Access Compliance Report

Public Rights-of-Way

(Curb Ramps)

Intersection ID: 27783	Main Street: BREM_LN	Cross Street: SAPONA_CT	Location: NE
ADA ID: 17ABDFD79BA8	Ramp Type: BlendTrans2	Initial Pass/Fail: Fail	Overall Compliance: No
			Severity Score: 33.75

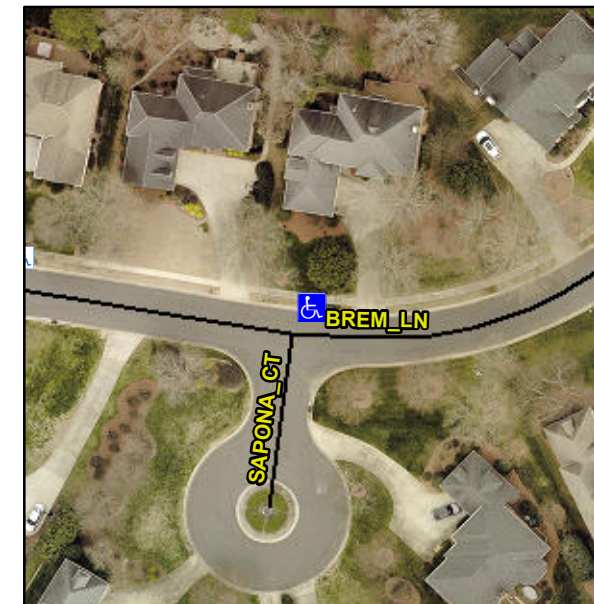
Not Found, R304.5.1, R304.5.3

Compliance	Description	Data	Compliance	Description	Data
N/A	Ramp Length (in)	98.0	Yes	BlendTrans Slope (%)	3.5
No	Ramp Width (in)	46.0	No	BlendTrans XSlope (%)	7.1
N/A	Flare Type LT	N/A	N/A	Flare Type RT	N/A
N/A	Flare Slope LT (%)	N/A	N/A	Flare Slope RT (%)	N/A
N/A	Flare Traversable LT?	N/A	N/A	Flare Traversable RT?	N/A
N/A	Landing Length (in)	N/A	N/A	DWS Provided?	N/A
N/A	Landing Width (in)	N/A	N/A	DWS Contrast?	N/A
N/A	Landing Slope (%)	N/A	N/A	DWS Length (in)	N/A
N/A	Landing X Slope (%)	N/A	N/A	DWS Full Width?	N/A
N/A	Landing Curb? (Y/N)	N/A	N/A	DWS Offset (in)	N/A
N/A	Shared Landing?	N/A			
N/A	Gutter Ponding?	N/A	N/A	Gutter Slope (%)	N/A
N/A	Gutter Lip Ht (in)	N/A	N/A	Gutter X Slope (%)	N/A
N/A	Painted X Walk1?	No	N/A	Painted X Walk2?	N/A
	X Walk 1 Direction	To S		X Walk 2 Direction	N/A
	X Walk 1 Width (in)	N/A		X Walk 2 Width (in)	N/A
	X Walk 1 Slope (%)	3.0		X Walk 2 Slope (%)	N/A
	X Walk 1 X Slope (%)	2.5		X Walk 2 X Slope (%)	N/A

N/A	Ramp inside XWalk1?	N/A	N/A	Ramp inside XWalk2?	N/A
	Road Slope (%)	2.5		Clear Space?	N/A
	Road X Slope (%)	3.0	N/A	Clear Space to XWalk (in)	N/A
N/A	Any Obstructions?	N/A	N/A	Storm Grate/Utility Hazard?	N/A
	Obstruction Type			Storm Grate/Utility Type	
		N/A			N/A
			Yes	Surface Condition? (G/P)	Good
			No	Curb Slope (%)	17.2

Remove & Replace Curb Ramp With Two New Directional Ramps or Equivalent.
